Facility Contingency Plan Regulation Update

Facility Regulatory Structure

State of California – Department of Fish and Wildlife
FACILITY CONTINGENCY PLAN COVER SHEET
DFW 456 (NEW XX/XX/XX) Page 2 of 7

§ 790 Definitions

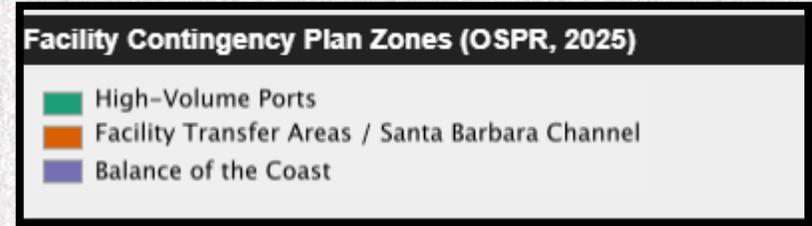
- **Comment:** Recommendation to recategorize ACP2 GRA7 as Balance of the Coast
- Action: OSPR added ACP2 GRA 7 to the Balance of the Coast definition.
- Note: ACP2 GRA 10 was incorrectly categorized on ERMA but was correctly included as a Facility Transfer Area in our definition section. This discrepancy has been resolved and is correct as OSPR regulates some facilities that conduct over-the-water transfers in ACP2 GRA10.
